**THE PORT AUTHORITY OF NEW YORK AND NEW JERSEY
TWO MONTGOMERY STREET - 1st FLOOR
JERSEY CITY, NJ 07302**

ADDENDUM NO. 9

TO PROSPECTIVE BIDDERS ON CONTRACT **EWR-154.395** – NEWARK LIBERTY INTERNATIONAL AIRPORT – TERMINAL A REDEVELOPMENT PROGRAM BRIDGES N61, N62, N63, AT-GRADE ROADWAYS AND APPURTENANCES AND CONTRACT **EWR-154.395M** – NEWARK LIBERTY INTERNATIONAL AIRPORT – AGREEMENT TO PERFORM LANDSCAPE MAINTENANCE

SKETCH SK-S01
ADDENDUM NO. 9

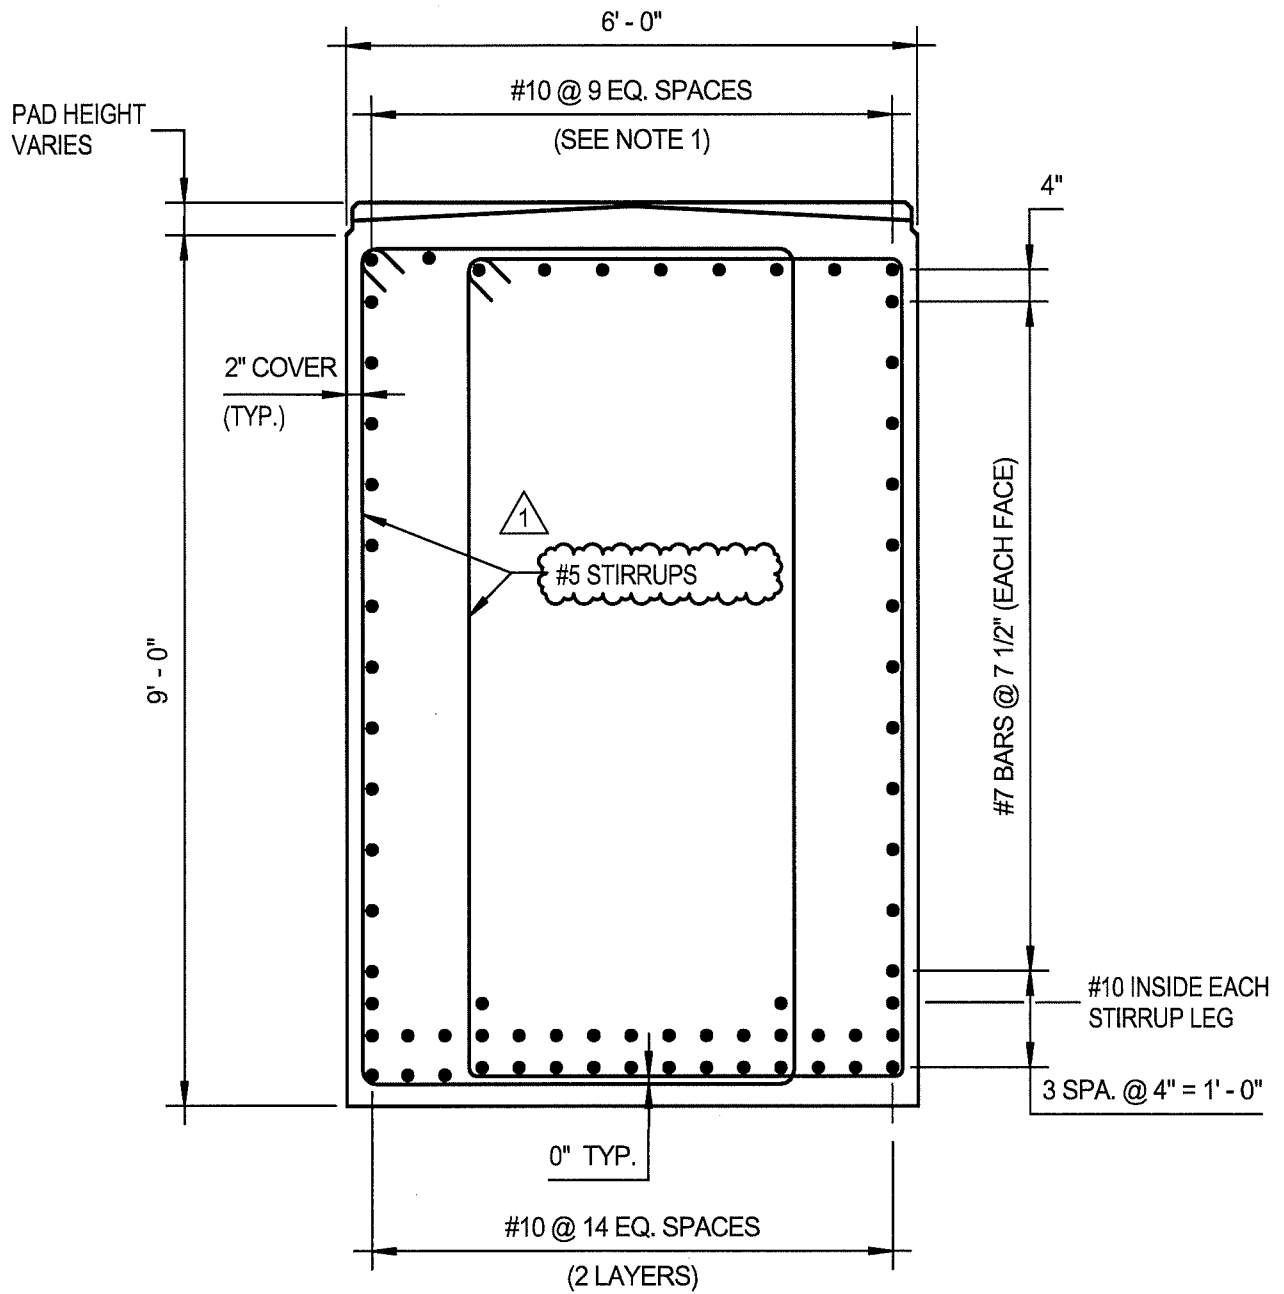
- Dwg. S0210 - Revise the drawing as shown in Sketch SK-S01 which is attached hereto and made a part hereof.
- Dwg. S0212 - Revise the drawing as shown in Sketches SK-S02 and SK-S03 which are attached hereto and made a part hereof.
- Dwg. S0214 - Revise the drawing as shown in Sketch SK-S04 which is attached hereto and made a part hereof.
- Dwg. S0237 - Immediately following the last sentence in Note 2., insert "UNLESS OTHERWISE NOTED, LOCATE JUNCTION BOXES 4'-6" MIN. FROM JOINTS IN THE CONCRETE BARRIER AND SPACE JUNCTION BOXES IN THE SAME CONDUIT RUN AT 300'-0" MAX."

SKETCH SK-E01

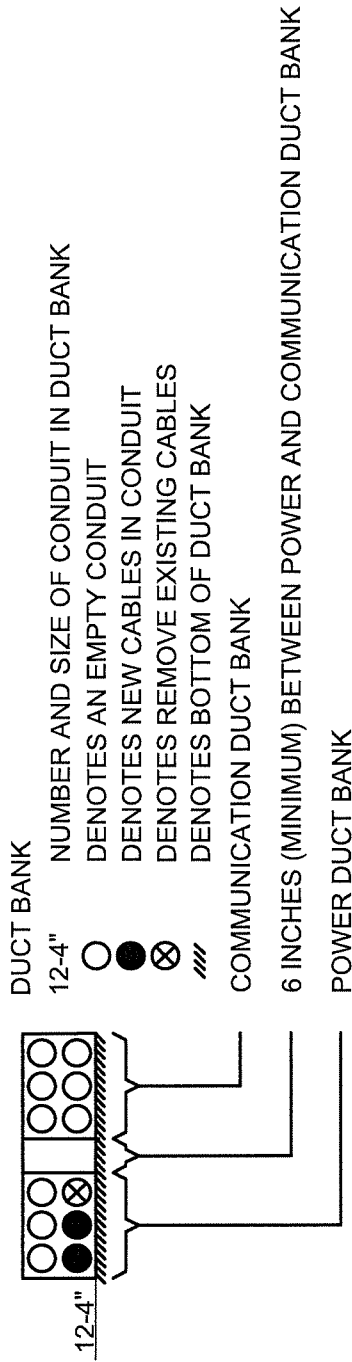
- Dwg. E0101 - Revise the drawing as shown in Sketches SK-E01, SK-E02 and SK-E03 which are attached hereto and made a part hereof.
- Dwg. E0203 - Revise the drawing as shown in Sketch SK-E04 which is attached hereto and made a part hereof.

SKETCH SK-E05
 ADDENDUM NO. 9

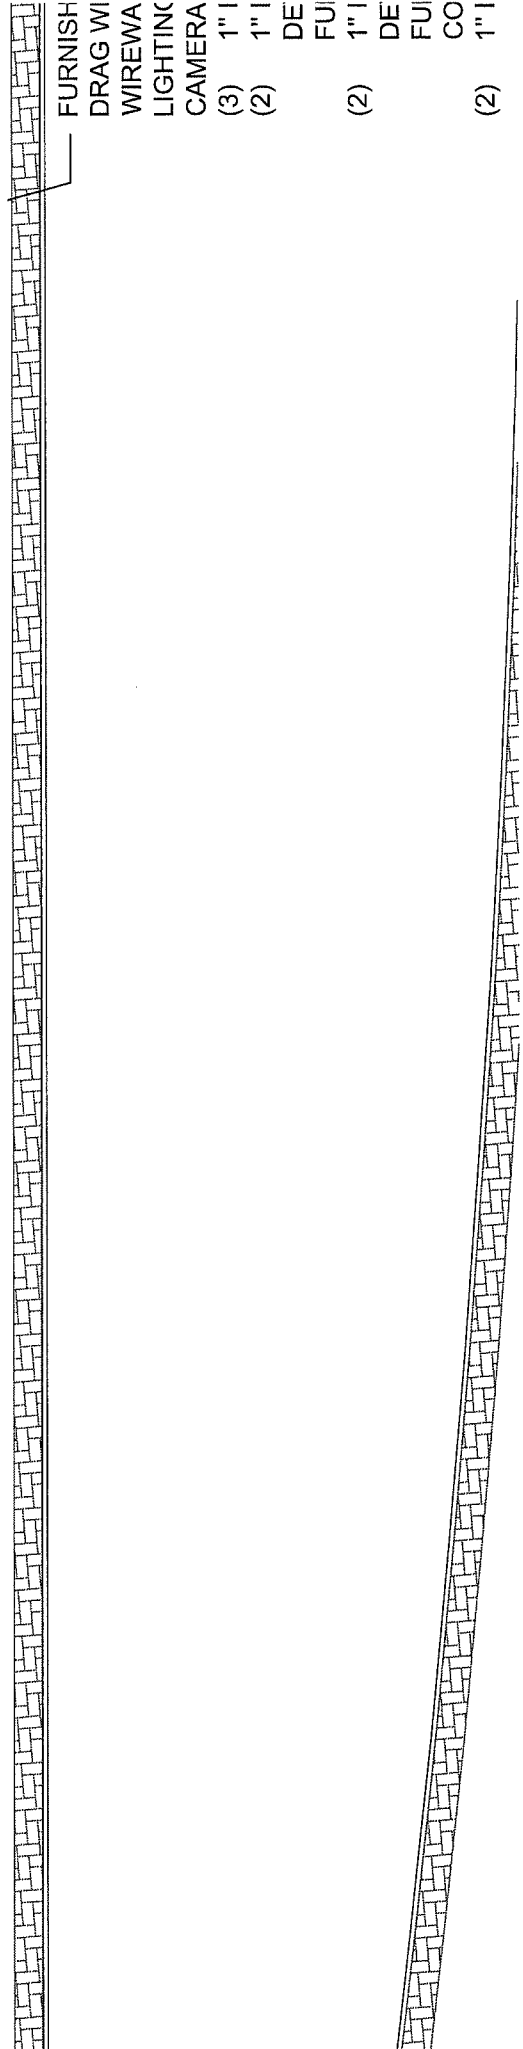
- Dwg. E0204 - Delete Note 15 in its entirety with no substitution therefor.
- Dwg. E0701 - Revise the drawing as shown in Sketches SK-E05 and SK-E06 which are attached hereto and made a part hereof.
